SUSQUEHANNA SES  
PRESSURE VESSEL FRACTURE TOUGHNESS PROPERTIES  
ER 100450                      FILE 840-2  
PLA-237

DOCKET NOS. 50-387  
AND 50-388

Attached are complete responses to the "Questionnaire for Fracture Toughness Properties of Older Reactor Vessels" contained in your December 6, 1977 letter. A partial response had been sent to you in our February 16, 1978 letter (PLA-218), since all of the data requested by you was not available at that time. The attached information consists of:

## Vessel Beltline Material Identification

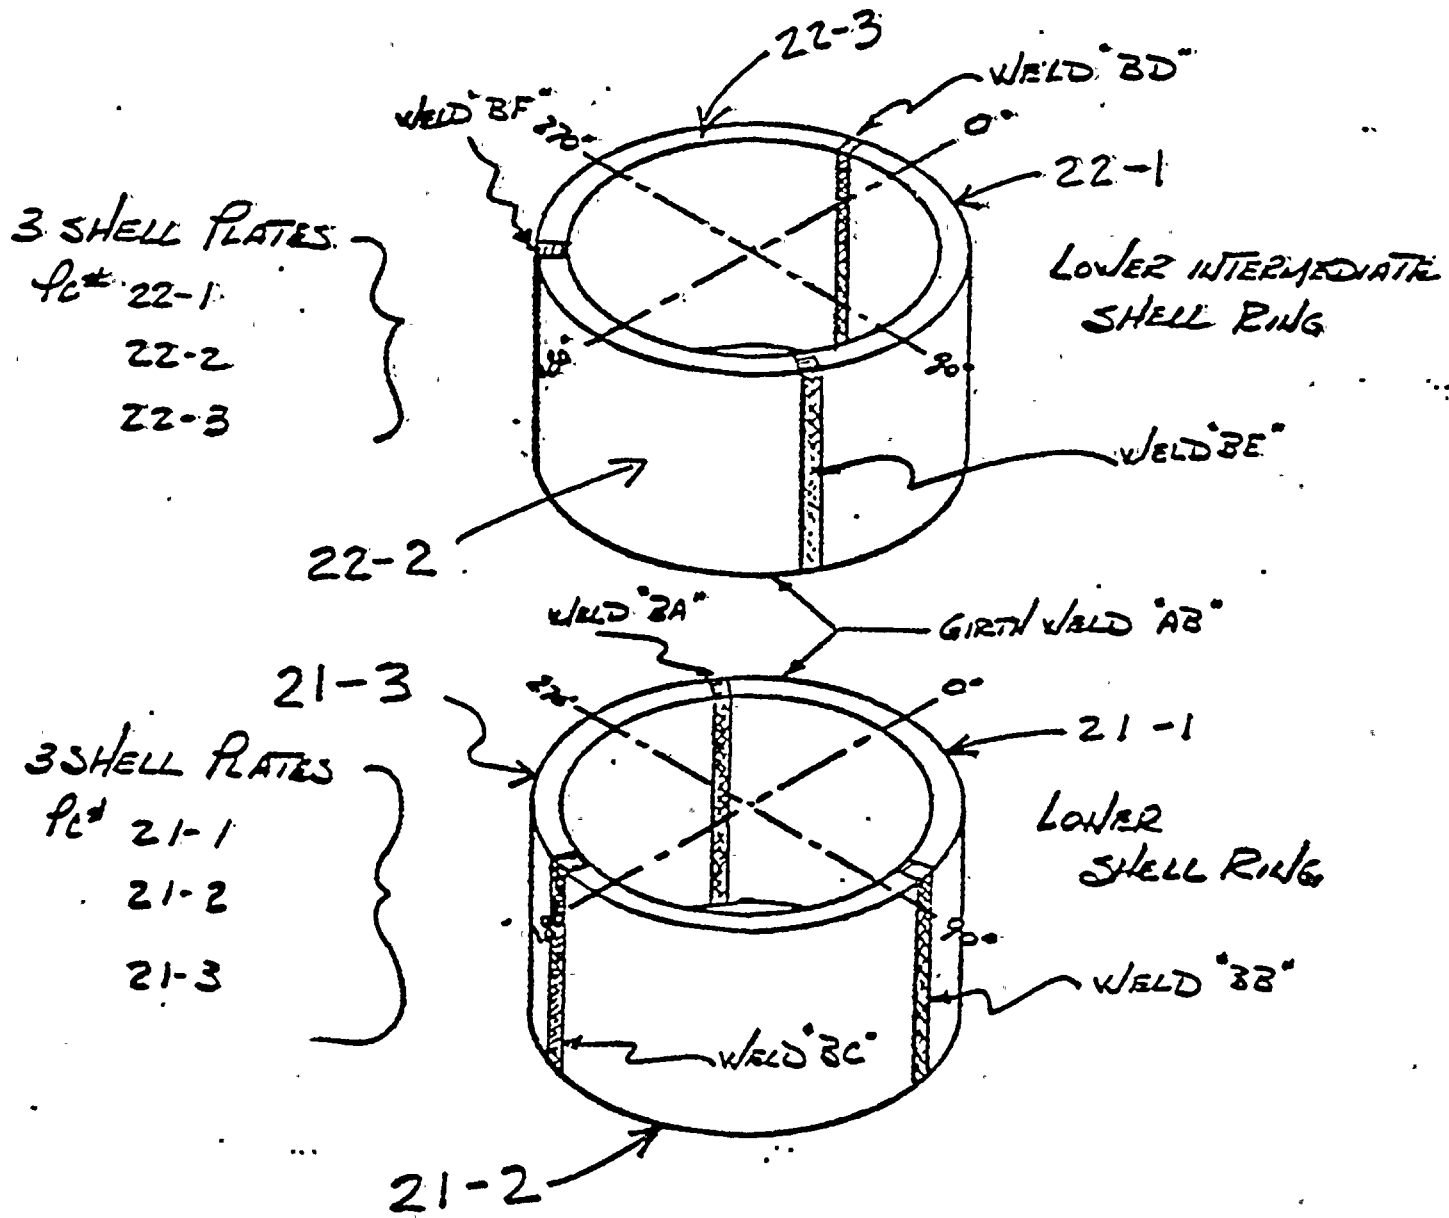
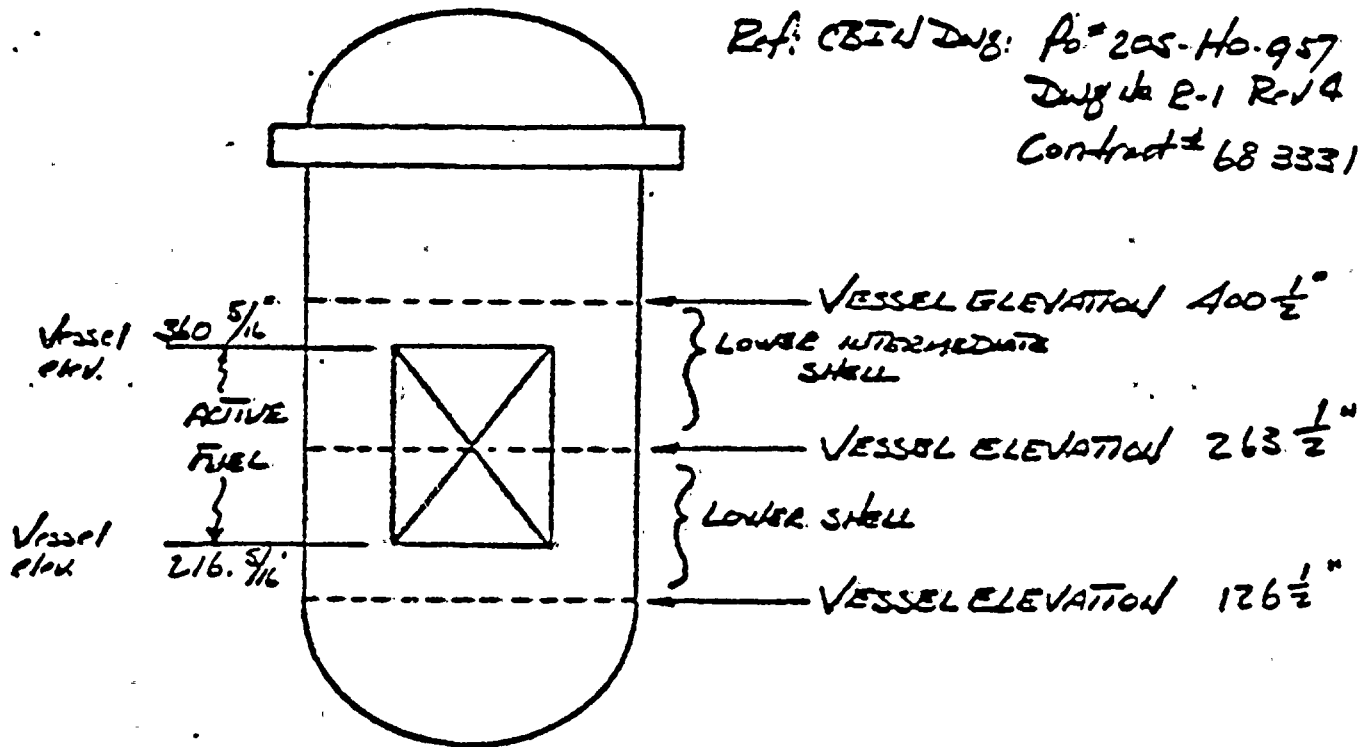
- 121.2 Identify each material (plate, and/or forging and weld metal) in the beltline region (as defined by paragraph II. H, Appendix G, 10CFR Part 50) and provide a sketch showing the location of these materials in the reactor vessel. Provide the following information for each material:
- (1) Chemical analyses; particularly those elements known to affect irradiation sensitivity and degrade the upper shelf fracture energy (Cu, P, and S).
  - (2) Unirradiated fracture toughness properties ( $T_{NDT}$ ,  $RT_{NDT}$  and upper shelf fracture energy) as required by Appendix G, 10CFR Part 50, identifying the limiting material in the reactor vessel beltline region.
  - (3) Estimate the maximum anticipated change in  $RT_{NDT}$  and upper shelf fracture energy as a function of the EOL fluence at the inner wall for the materials in the beltline region of the reactor vessel.

- 121.2 Materials in the reactor pressure vessel beltline region are identified as listed below and as shown on the attached sketch:

A. Lower Shell Course (CBIN Dwg R-1, Rev. 4, Contract No. 683331)

<u>PC #</u>	<u>ID #</u>	<u>MELT #</u>	<u>SLAB #</u>
21	1	CB5083	1
21	2	C0770	2
21	3	C0814	2

## Vessel Beltline Material Identification

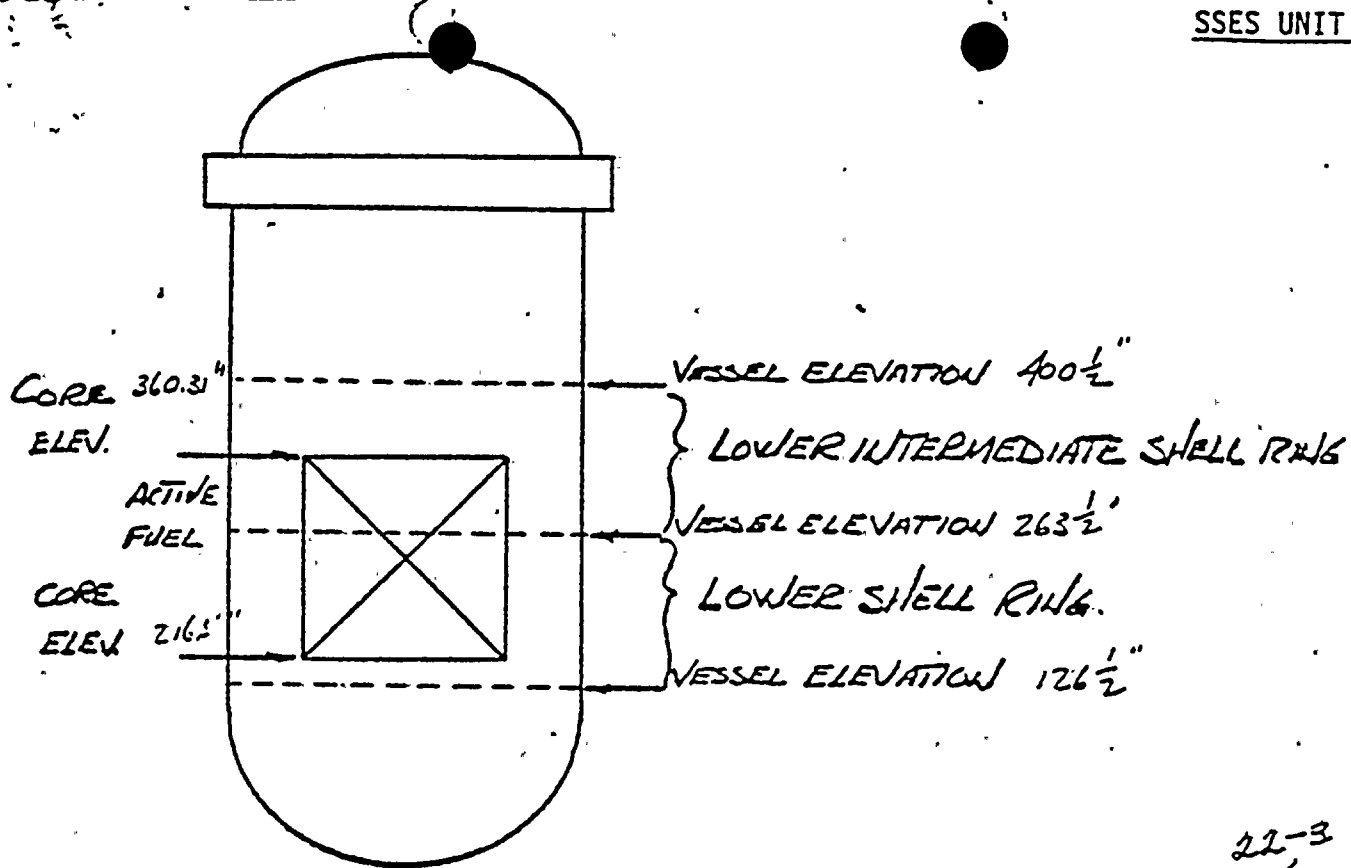
- 121.2 Identify each material (plate, and/or forging and weld metal) in the beltline region (as defined by paragraph II.11, Appendix G, 10CFR Part 50) and provide a sketch showing the location of these materials in the reactor vessel. Provide the following information for each material:
- (1) Chemical analyses; particularly those elements known to affect irradiation sensitivity and degrade the upper shelf fracture energy (Cu, P, and S).
  - (2) Unirradiated fracture toughness properties ( $T_{NDT}$ ,  $RT_{NDT}$  and upper shelf fracture energy) as required by Appendix G, 10CFR Part 50, identifying the limiting material in the reactor vessel beltline region.
  - (3) Estimate the maximum anticipated change in  $RT_{NDT}$  and upper shelf fracture energy as a function of the EOL fluence at the inner wall for the materials in the beltline region of the reactor vessel.

121.2 Materials in the reactor pressure vessel beltline region are identified as listed below and as shown on the attached sketch:

LOWER INTERMEDIATE SHELL  
(3 PLATES)

- PC# 22-1 Heat# C2421, SLAB# 3
- PC# 22-2 " C2929, " 1
- PC# 22-3 " C2453, " 2

LOWER SHELL  
(3 PLATES)

- PC# 21-1, Heat# 6C956, SLAB# 1-1
- PC# 21-2, " 6C980, " 1-1
- PC# 21-3, " 6C1053, " 1-1
